Office Action Summary

10/539,581

HYEON, SEONG-YEOL

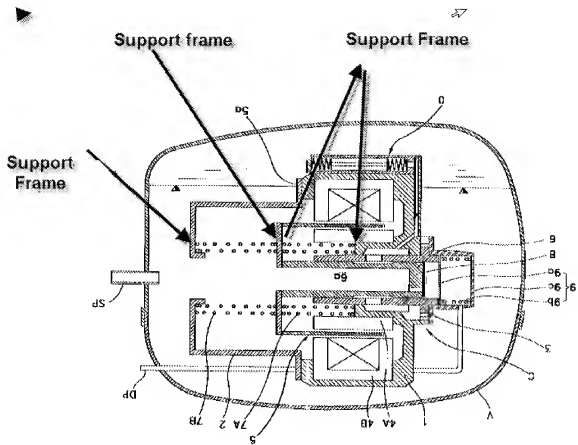
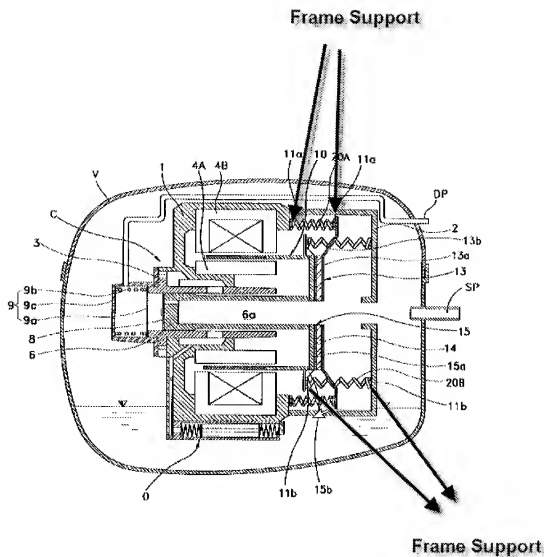
Song teaches reciprocating compressor comprising: a reciprocating motor (4a, 4b) disposed in a casing, and configured to generate a driving force (col. 1 lines 63-67); a compression unit C configured to suck, compress, and discharge gas by the driving force of the reciprocating motor; a resonant spring unit (7A, 7B or 20a, 20b) configured to provide a reciprocating movement of the reciprocating motor with a resonant movement; and at least two spring supporting frames (2, 5a or 2, 13b) configured to support the resonant spring unit, wherein one of the spring supporting frames is inserted into another of the spring supporting frames. Please note that frames 13b and 5a are within frame 2.

Applicant's arguments filed 2/29/08 have been fully considered but they are not persuasive. Applicant states that Song lacks the teaching of one supporting frames inserted into another of the supporting frames. Please note that the examiner has interpreted the reference of Song as containing 4 frames and some of the frames are surrounded or inserted into other frames as seen in the figures above.
